**TAKE NOTICE THAT A REGULAR MEETING
OF THE BOARD OF COMMISSIONERS
OF THE CITY OF PHARR, TEXAS
WILL BE HELD AT CITY HALL, COMMISSIONERS' ROOM,
118 S. CAGE BLVD., 2ND FLOOR, PHARR, TEXAS
COMMENCING AT 4:00 PM ON
MONDAY, DECEMBER 1, 2025**

E) Consideration and action, if any, on Change Order Number 2 in the amount of \$49,781.94 and the addition of 15 working days to the construction contract with D. Wilson Construction Company for the Donation Acceptance Program for Fiscal Year 2016. **This item supports IF - Infrastructure.** (ENGINEERING)

**Project: 24-235 Pharr FY16 DAP - Agricultural
Lab, Dock Expansion I & II**
9901 S Cage Blvd
Pharr, Texas 78577

SCALE: AS NOTED	SHEET 1 OF 1			
DN:	CONT	SECT	JOB	HIGHWAY
CK DN:	921	02	424,425,433	PHARR INT. BRIDGE
DW: IE				
CK DW: RD				
TR:	DIST	COUNTY		SHEET NO.
CK TR:	PHR	HIDALGO		C-401A

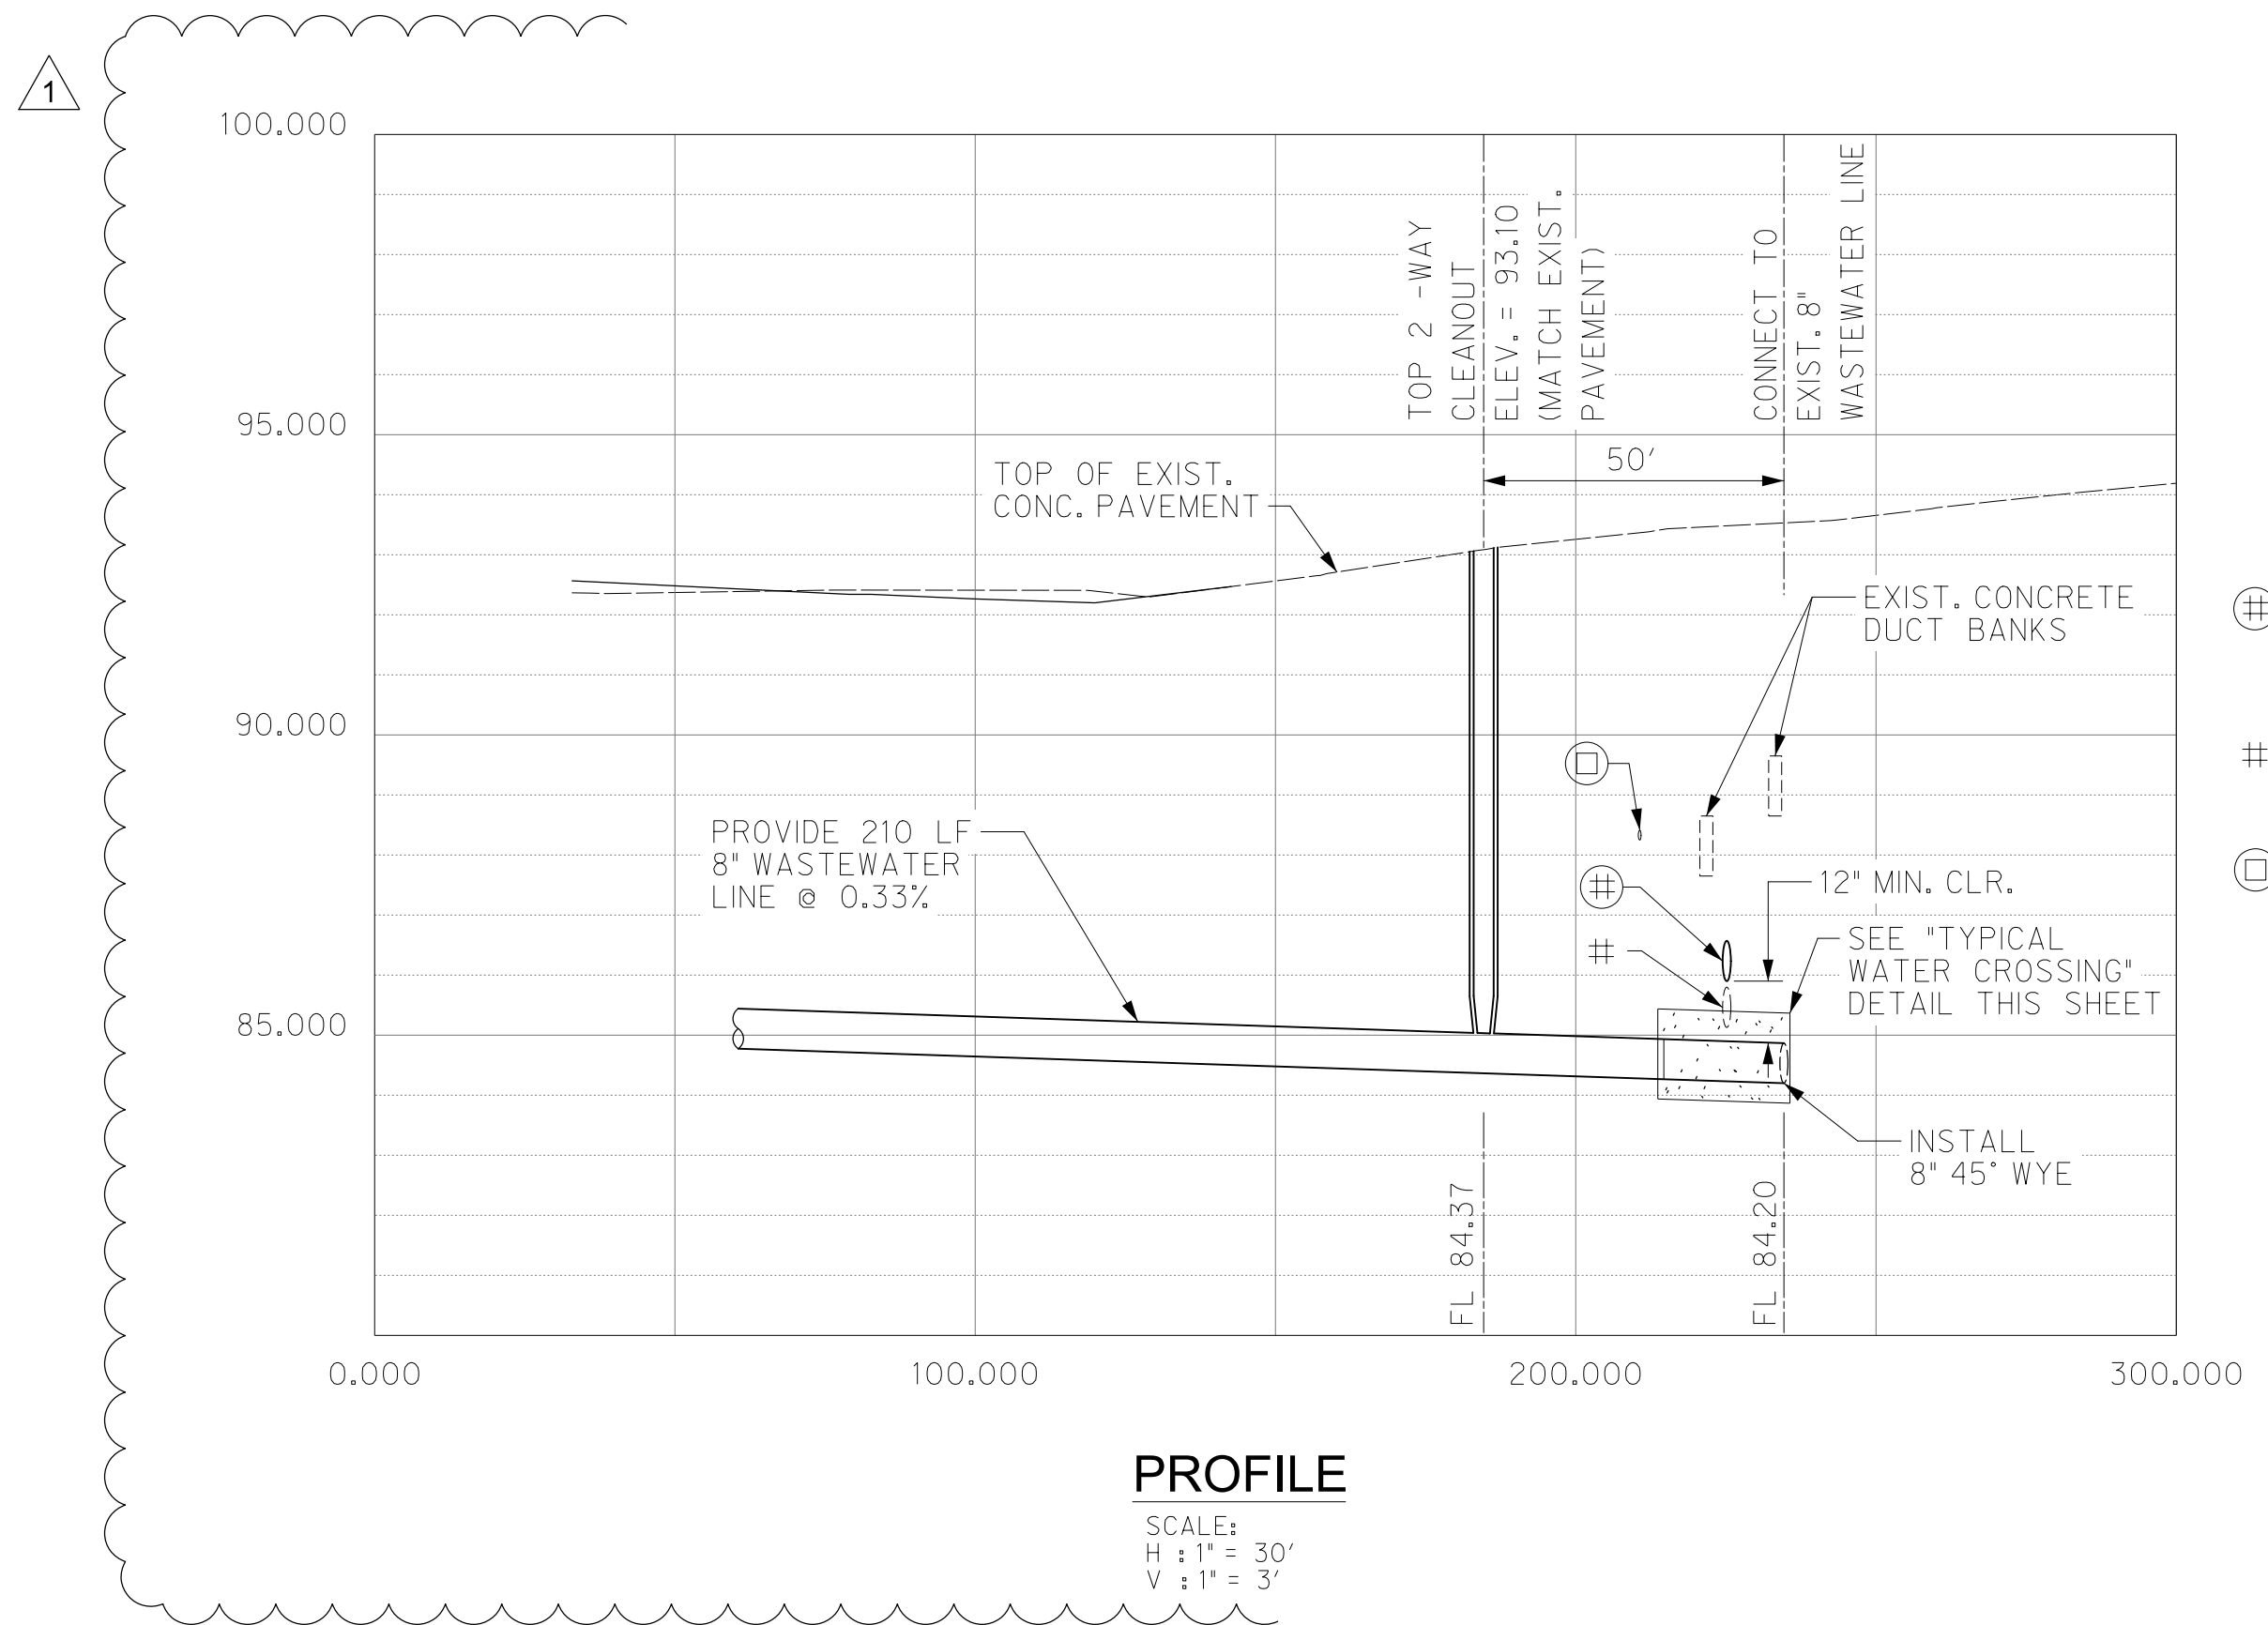
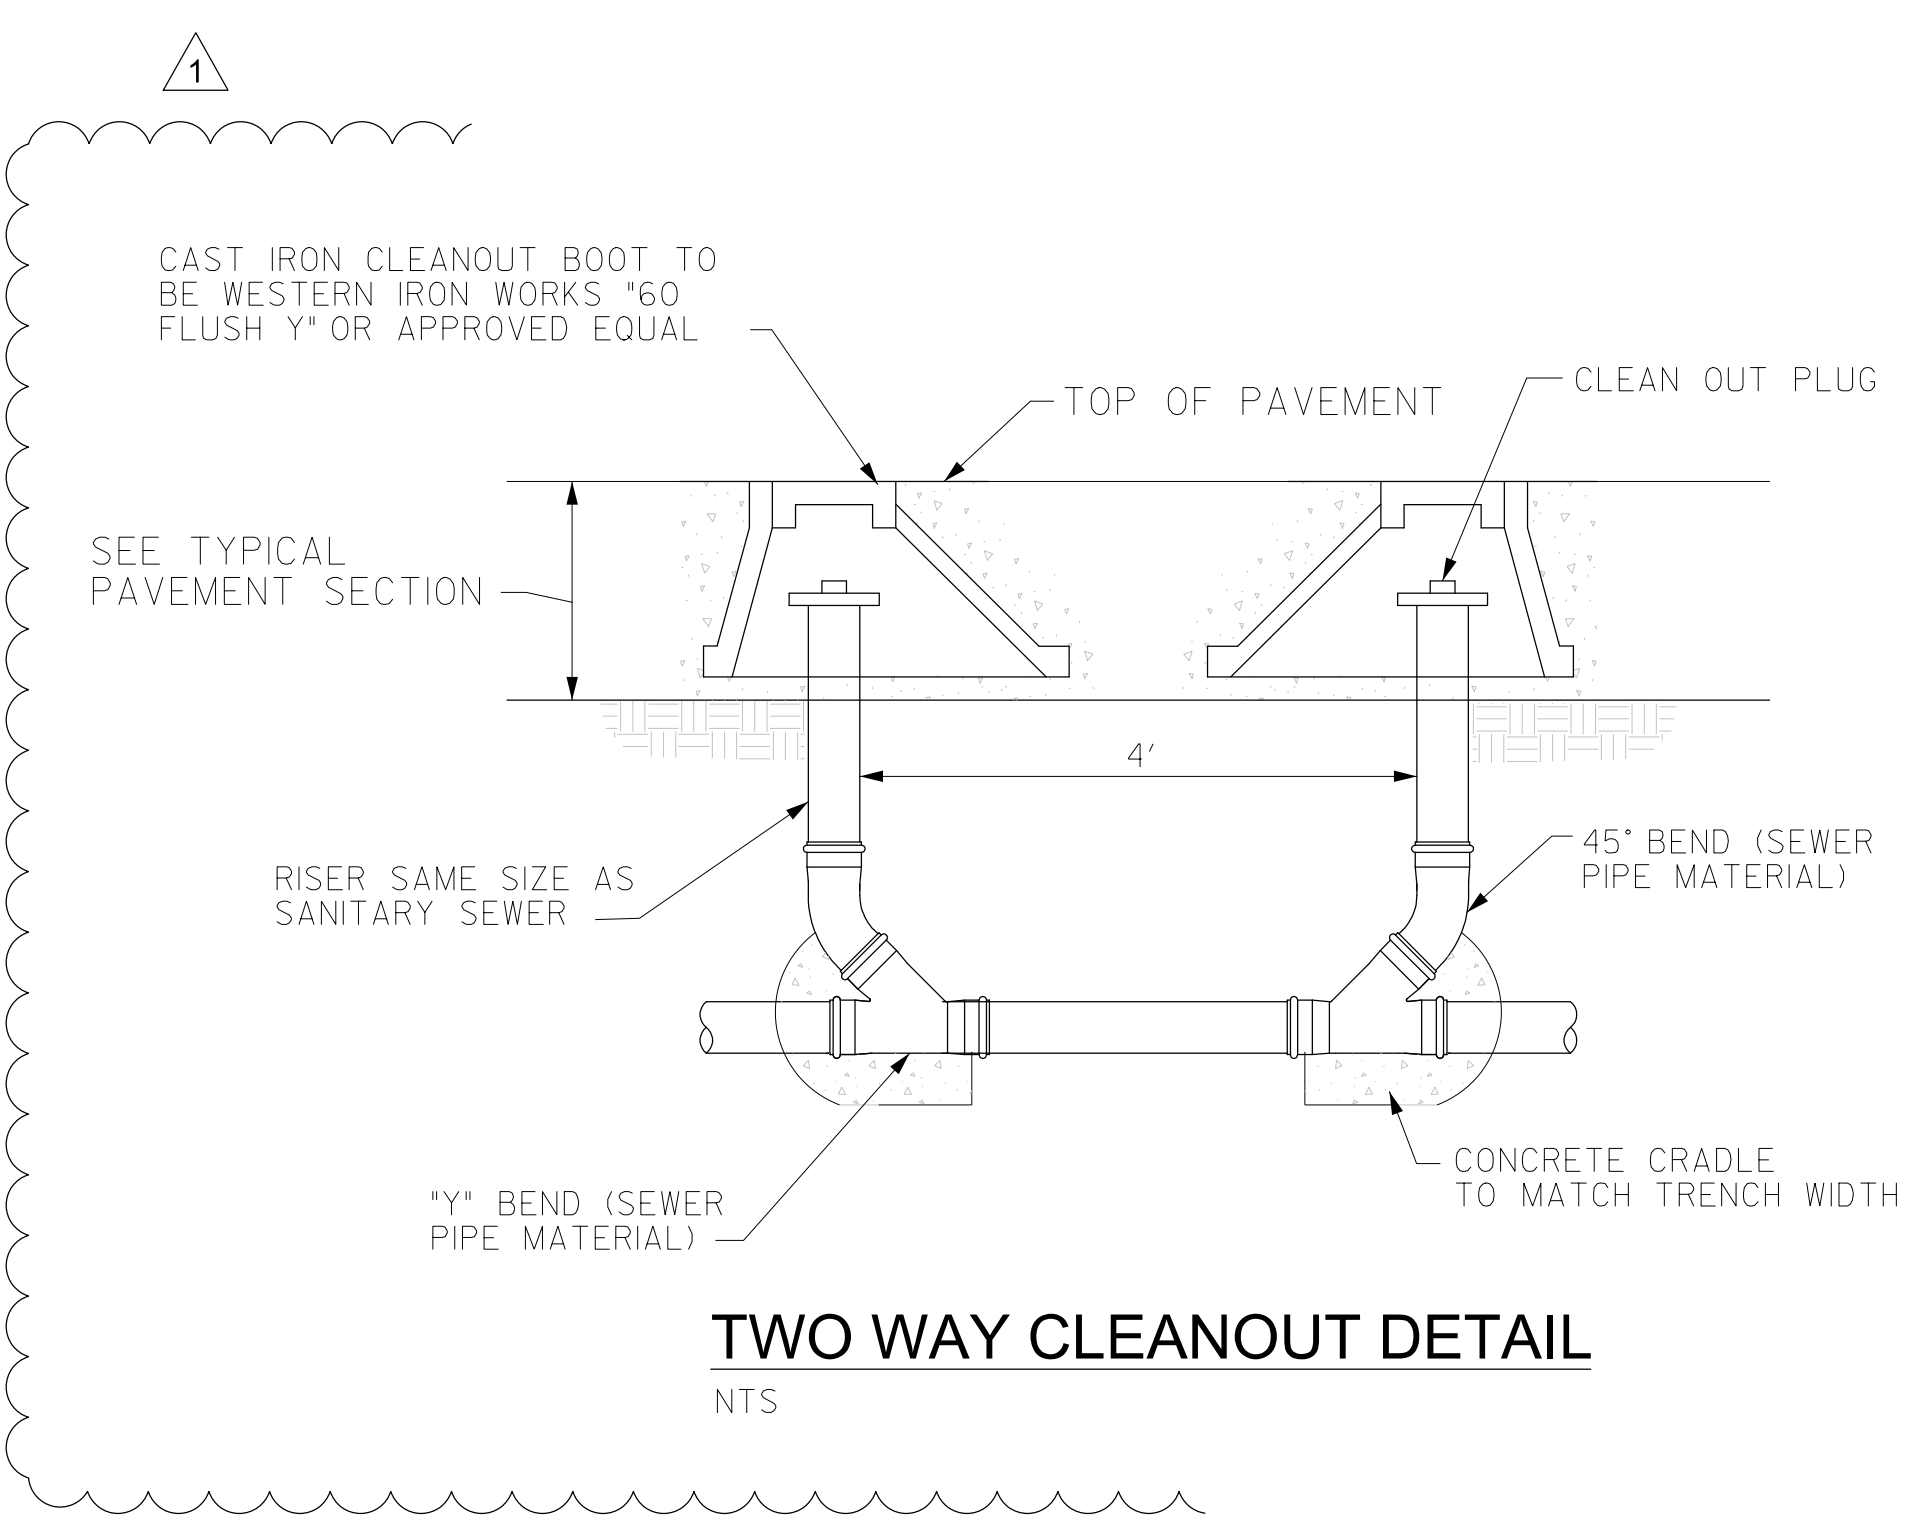
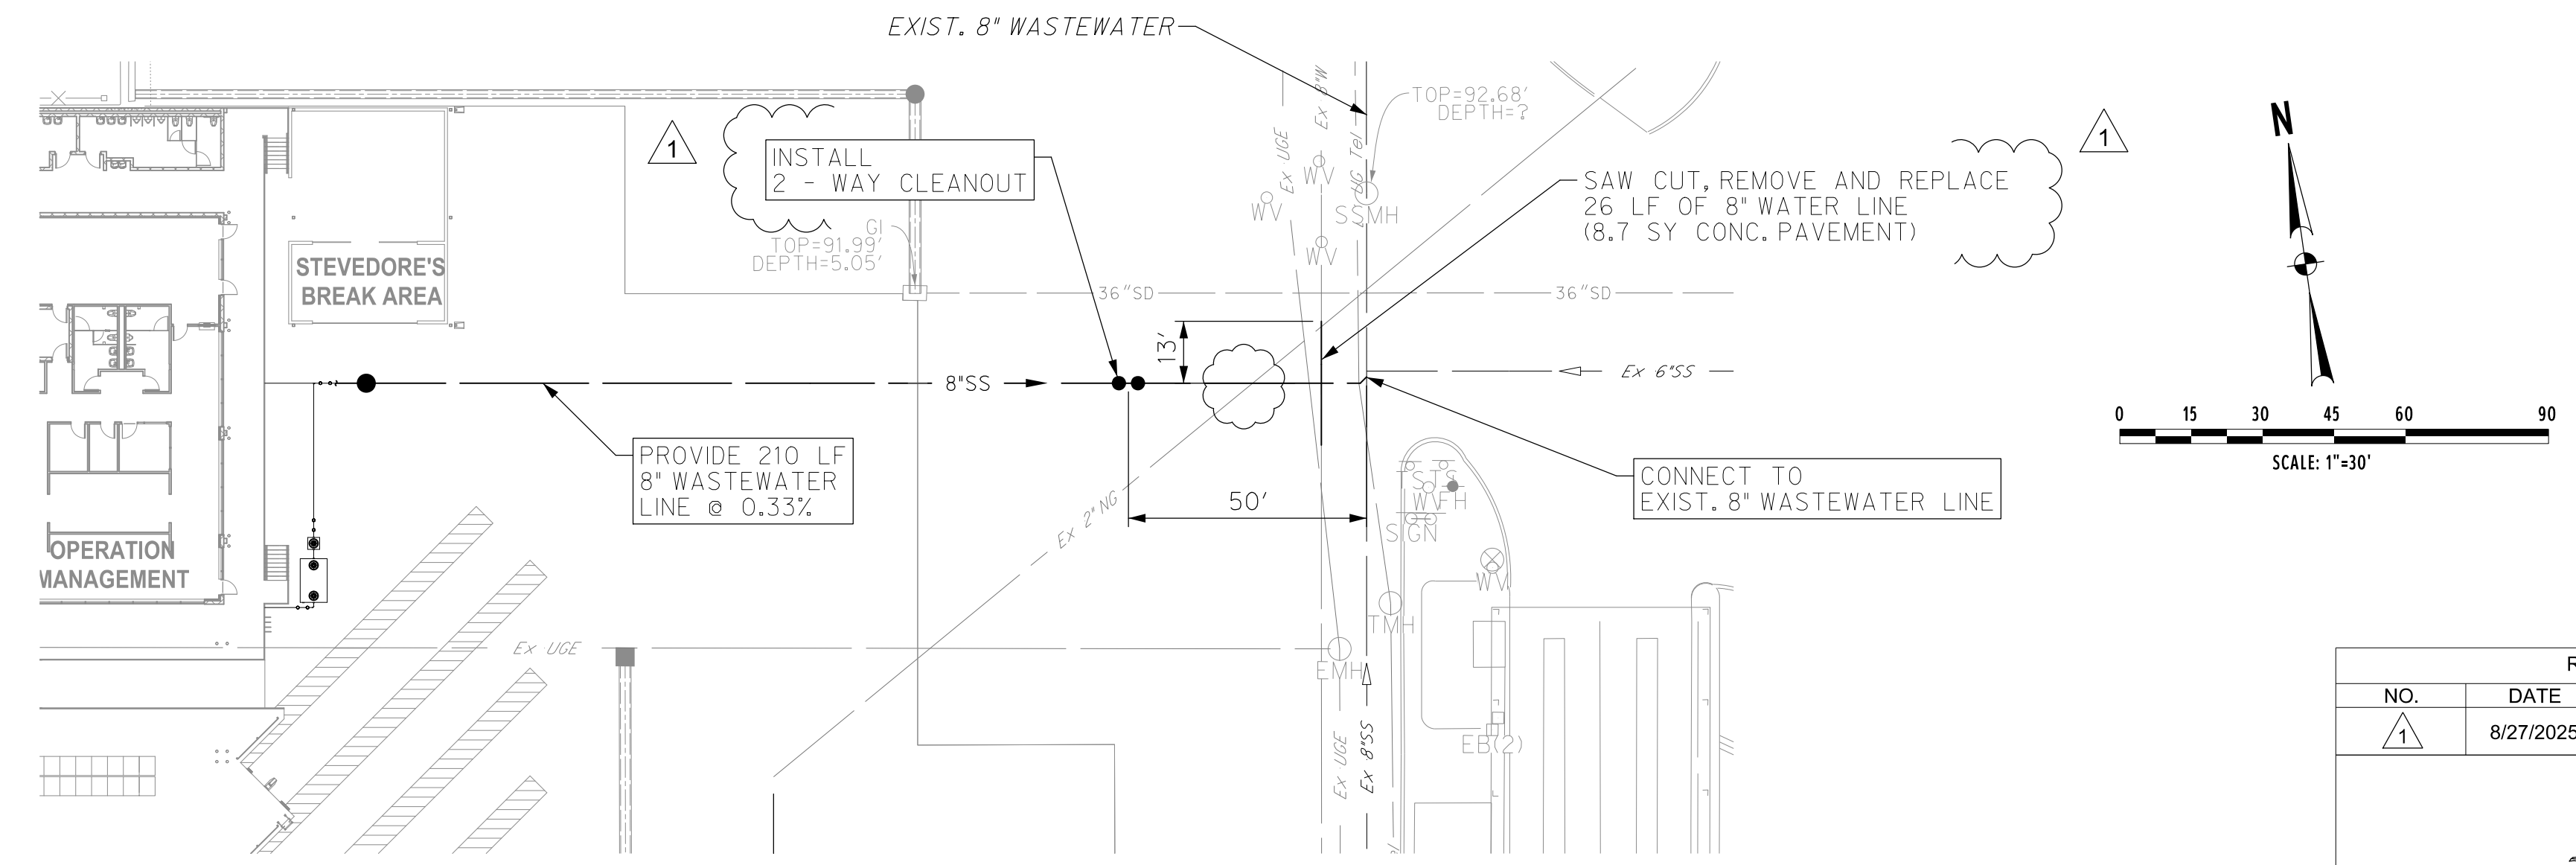
- This sheet has been created in response to RFI #84 – 48" Concrete Manhole.
- This sheet is supplemental to Plan sheet C-401.
- This sheet includes plan, profile, and utility details required to connect the proposed 8-inch sewer line to the existing 8-inch facility sewer line, eliminating the need for the previously proposed sanitary sewer concrete manhole.

Refer to the attached sheet C-401A Utility Plan for information regarding the connection between the proposed 8-inch sewer line and the existing 8-inch facility sewer line.
